**SUBJECT:** NuScale Power, LLC Supplemental Response to NRC Request for Additional Information No. 151 (eRAI No. 8974) on the NuScale Design Certification Application

## **Response to Request for Additional Information Docket No. 52-048**

**eRAI No.:** 8974

**NRC Question No.:** 03.08.04-23

**Figure 3.7.2-169: In-Structure Response Spectra at Node 6329 due to X, Y, and Z Inputs of Capitola Excitation for Soil Type 7, Cracked Condition**

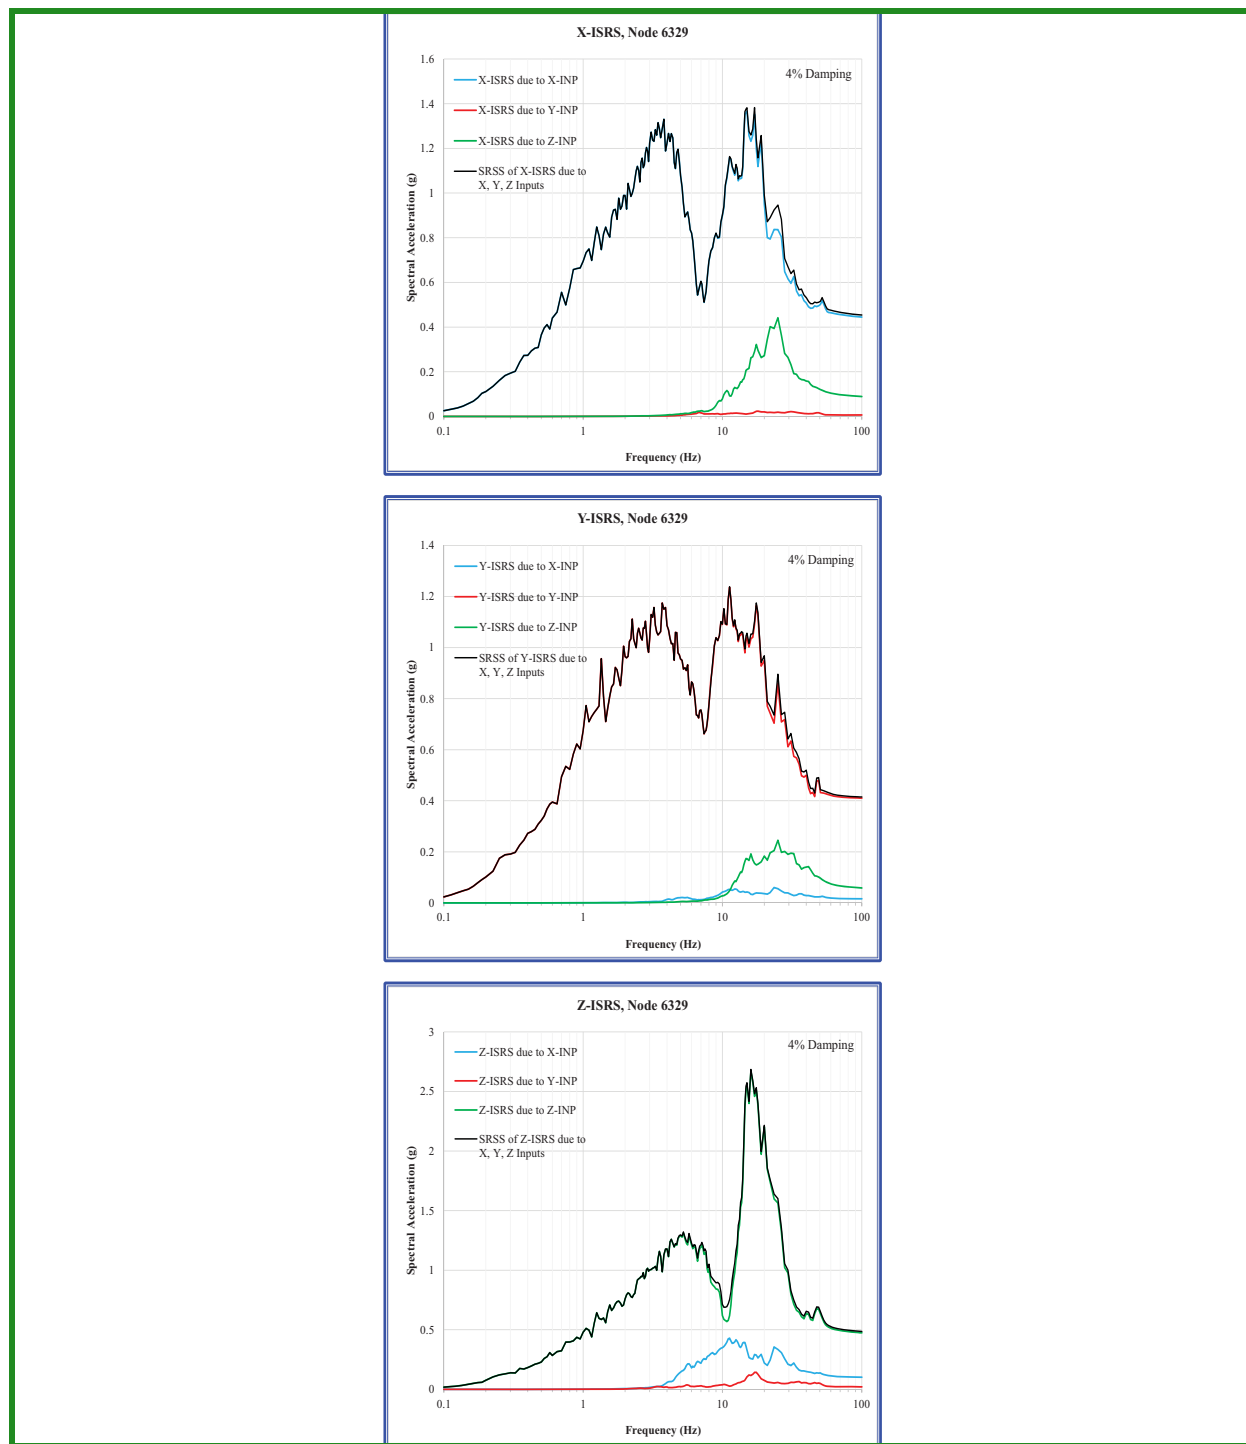
3. **Question:** Additionally, please provide FSAR markups to include an ISRS at the RFT location that is consistent with the input used for the seismic analysis of the lower RPV at the RFT location. Also please, provide markups to identify the nodes and respective location (e.g. tables and or figures)

**Response:** The ISRS at the RFT location are added as FSAR Figures 3.7.2-164 through 3.7.2-171 and the coordinates of the selected RFT nodes are provided in FSAR Table 3.7.2-58, as shown in the attached FSAR mark-up.

Response spectra are generated for time histories at four reactor flange tool (RFT) base locations. The coordinates of these ISRS locations are listed in Table 3.7.2-58. For each case, there are 12 (3 directions x 4 locations) ISRS generated. For the two analysis cases (cracked and uncracked concrete), the total number of ISRS is 24 (12 x 2 cases). The plots of the ISRS are presented in Figure 3.7.2-164 through Figure 3.7.2-171.
